# SUZUKI

# Service Bulletin

Subject: GT380/550/750 BATTERY BREATHER  
LOCATION

Bulletin No: GT-14

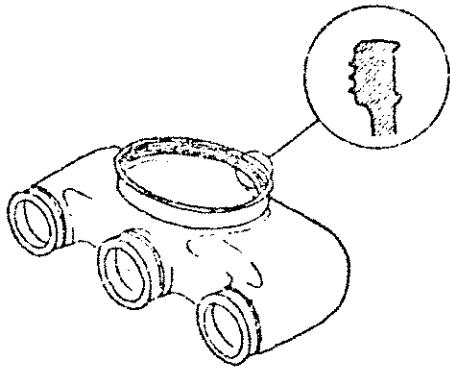
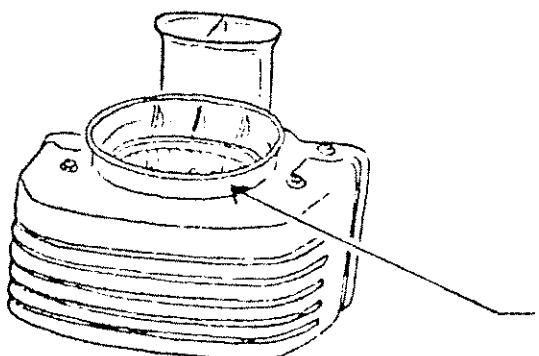
The sealing procedure depends on the type of the carburetor air inlet hose as shown below.

OLD TYPE

NEW TYPE

1. OLD TYPE

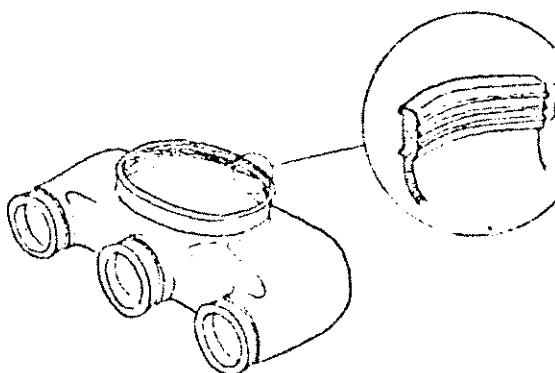
CAUTION:

DO NOT APPLY SUZUKI BOND NO. 4  
ON AIR INLET HOSE, OTHERWISE  
IT MAY CAUSE CLOGGING OF THE  
CARBURETOR.

COAT WITH "SUZUKI BOND NO. 4"  
ALL AROUND.

2. NEW TYPE

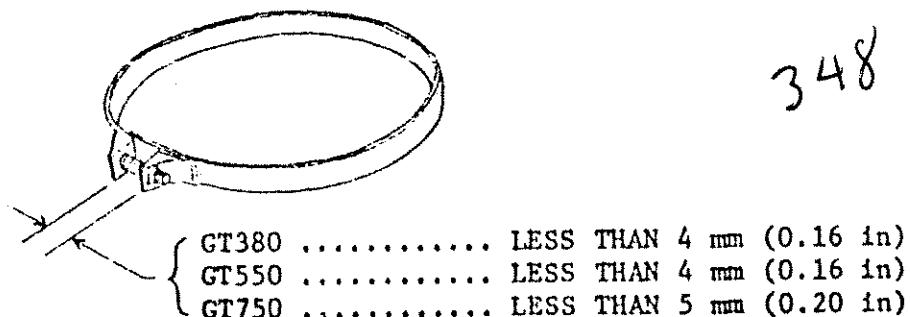
COAT WITH "SUZUKI BOND NO.  
4" ALL AROUND.

1. The sealant should be dried for about 3-6 minutes before installation.
2. The clamp should be tightened as explained below.

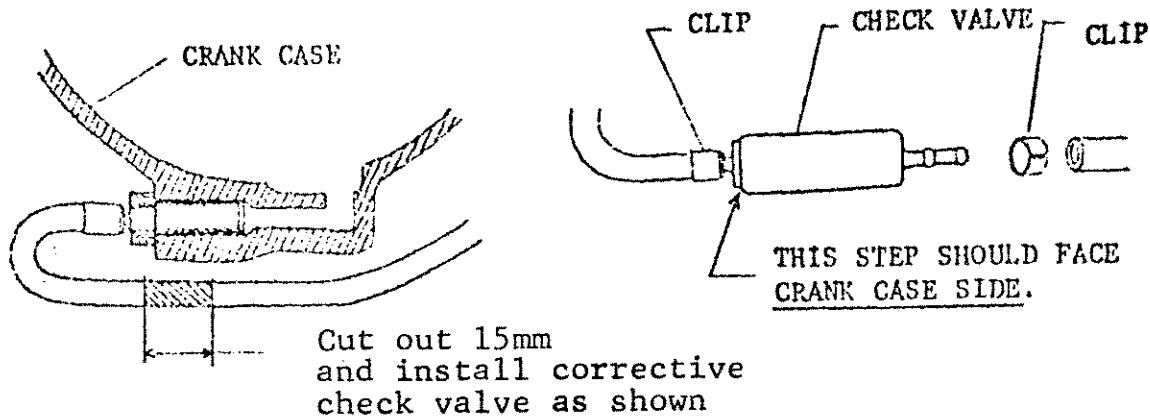
As you may be aware, the K series GT models have had an oil strainer added to the SRIS check valve in order to prevent clogging of the valve and consequently excessive smoking of the motorcycle. Also the valve has been changed from a press fitted type to that of a threaded type. However, the original strainer being constructed of a plastic material, has been found unable to withstand the high speed riding. Therefore, the plastic oil strainer material has been changed to metal.

PART DESCRIPTION	OLD PART NO.	NEW PART NO.
Strainer	16521-31080	16521-31010

The old and new type strainers are interchangeable, however the old type should be avoided, since the new type is available.

PARTS INTERCHANGEABILITY:

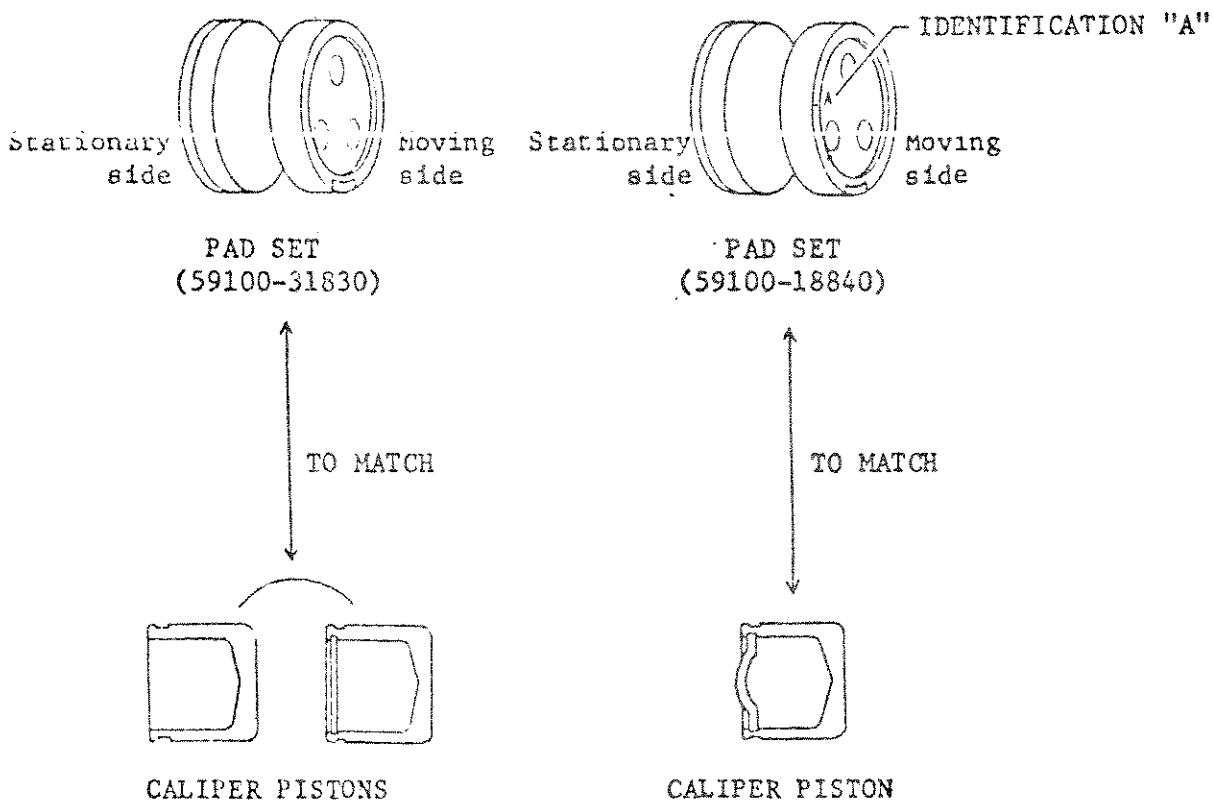
Two pad sets are supplied. Part Number 59100-31830 is for use with the old style pistons. Part Number 59100-18840 is for use with the new style piston. This is illustrated below.

Failure to correctly match these parts could cause the pads to crack or the disc wheel to drag severely.

NOTE: The modified moving brake pad is identified by an "A" stamped on its metal back.

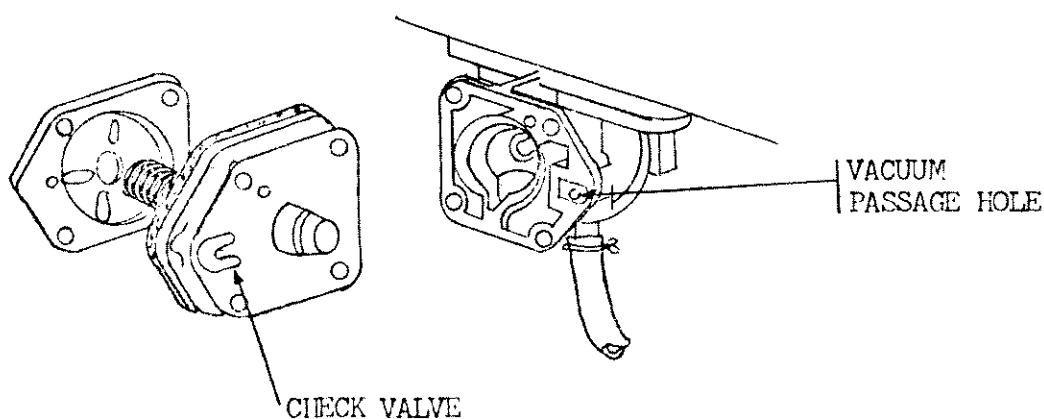
We have received reports of some 1974 GT380L, GT550L, and GT750L's starving for fuel at high RPM's.

During factory testing, it was found that the new style fuel cock's vacuum passage was being partially blocked by the diaphragm check valve,

1. Remove the fuel tank from the affected unit and empty its contents.
2. Using a #1 Phillips head screw driver, remove the diaphragm cover and diaphragm assembly from the fuel cock's body.
3. Using a 6mm (15/64 in.) bit and drill, chamfer the vacuum passage hole as much as possible without removing any material from the bodies diaphragm mating surface. The vacuum passage hole is shown below.
